January 28, 2005

**Subject: Rio Algom Mining, LLC; Docket 40-8905
Response to Request for Additional Information for the
Closure Plan – Lined Evaporation Ponds at Rio Algom Mining
LLC's Ambrosia Lake Facility (TAC LU0070)**

**RIO ALGOM MINING COMPANY'S RESPONSE TO REQUEST FOR
ADDITIONAL INFORMATION FOR THE CLOSURE PLAN -LINED
EVAPORATION PONDS AT RIO ALGOM MINING LLC'S AMBROSIA LAKE
FACILITY (TAC LU0070)**

RAI Figure 3. Gamma Radiation Survey Results

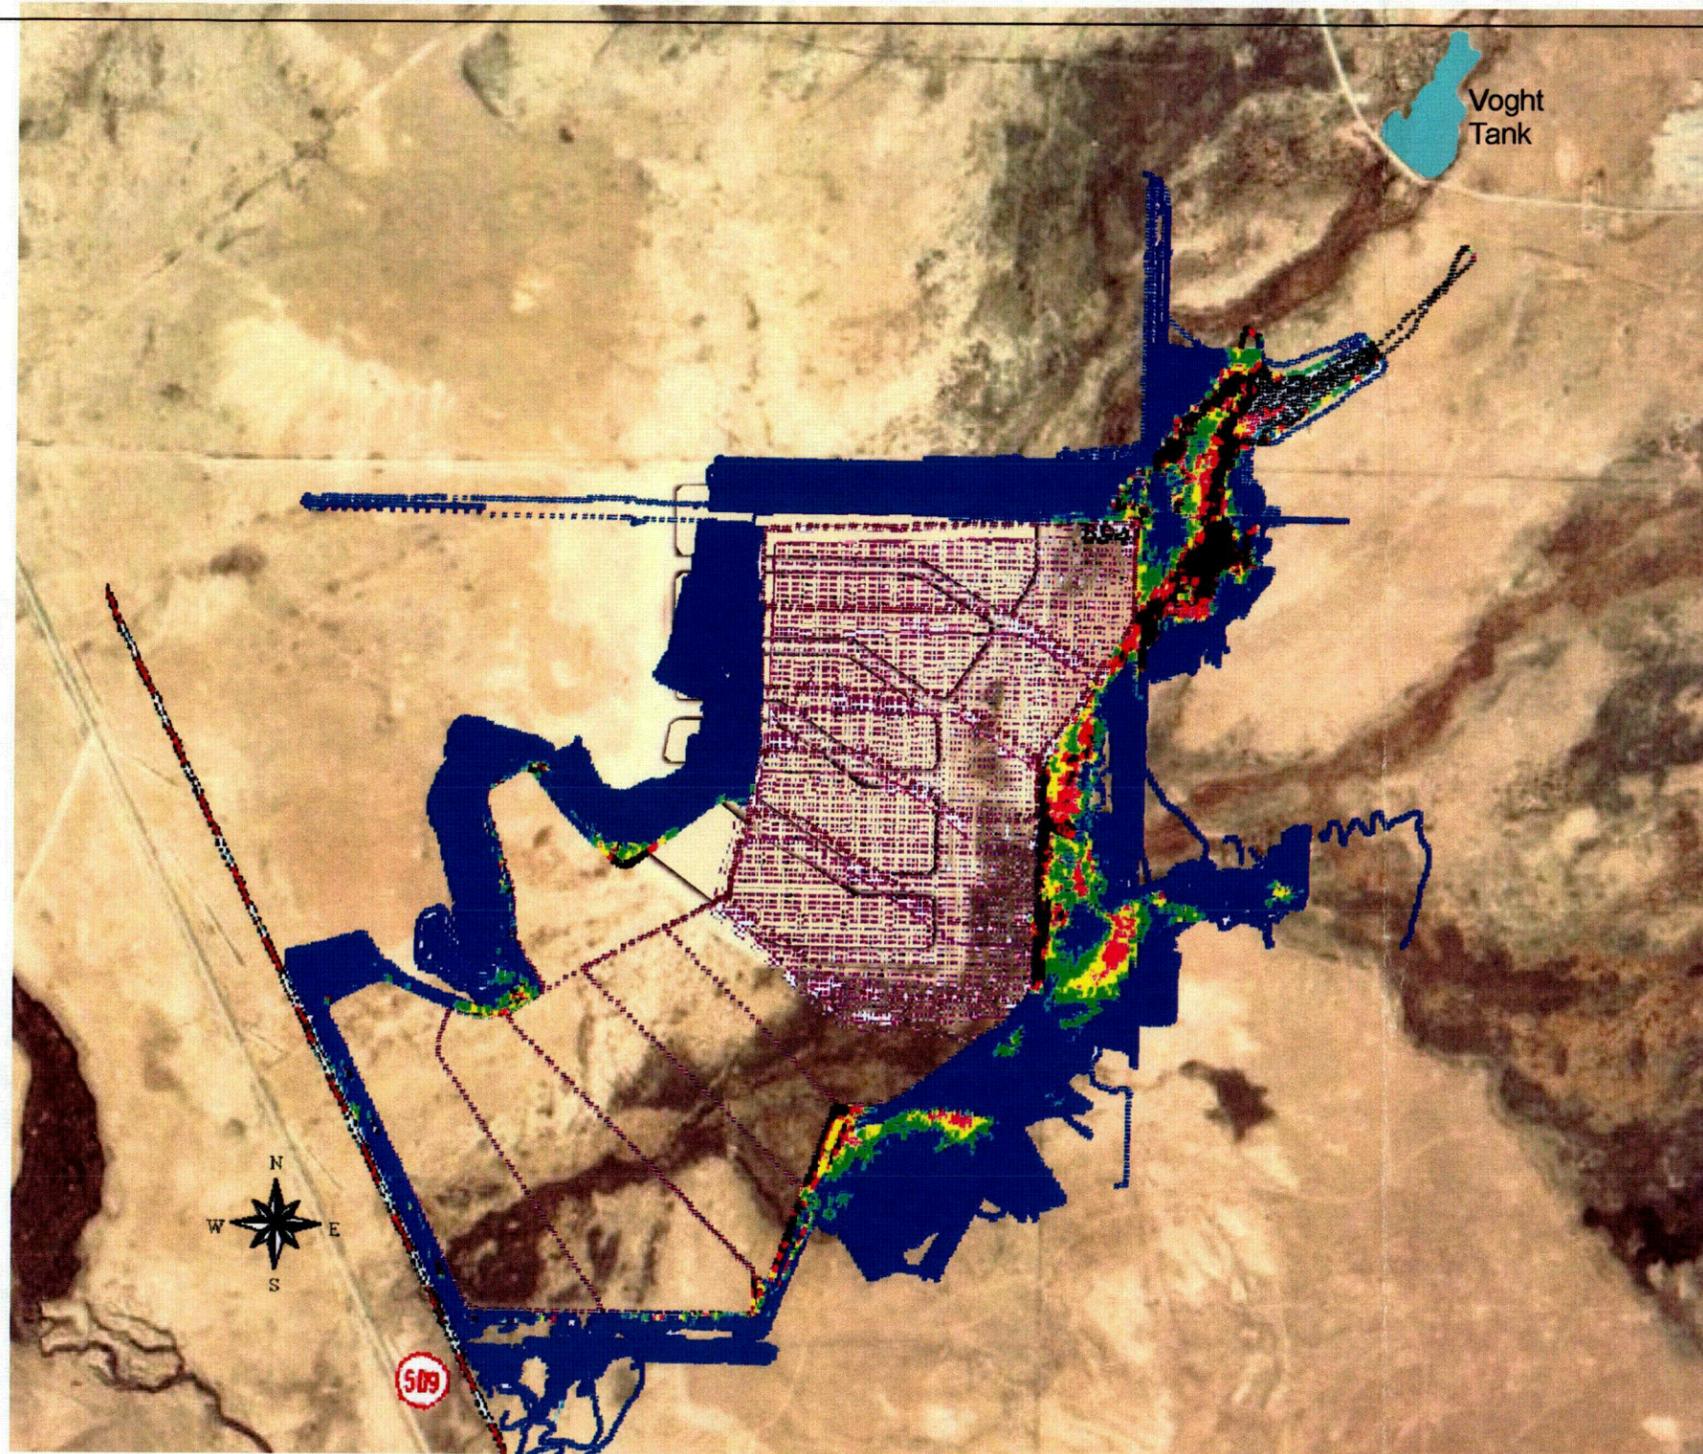
Request: Provide a map of the gamma survey results with individual color points visible and an explanation of the gamma range represented by each color. Also, describe the Voght tank.

Gamma radiation surveys performed as part of the DOE UMTRA surface reclamation at the former UNC (Phillips) Mill, identified elevated radiation levels within the drainages into and out of Voght Tank. DOE included these drainages, down to and including Voght Tank sediments, within the site cleanup plan; but the dam and drainages downstream from Voght Tank were not included in the DOE site cleanup plan.

Rio Algom performed preliminary characterization surveys to support the visual evidence of impacts attributable to the mine dewatering activities that flowed to and through the Section 4 area prior to pond construction. Presentation of this information (Figure Gamma map #) is intended to support this contention.

As was previously discussed, Voght Tank existed prior to commencement of mining activities in the Ambrosia Lake area. Voght Tank is a manmade stock tank that was subsequently used as the collection point for surface waters entering the UNC mine/mill complex canal system (Section 28 T14N R9W) (Figures 1 and 2). Field observations indicate that the Voght Tank earthen dam contains waste rock materials that exhibit elevated radiation levels, indicating that the berm of the tank was enlarged following mining activities, likely to contain the additional water supplied by the mine dewatering activities. The stock tank has not been used in the recent past and only receives water as surface runoff as a direct result of precipitation.
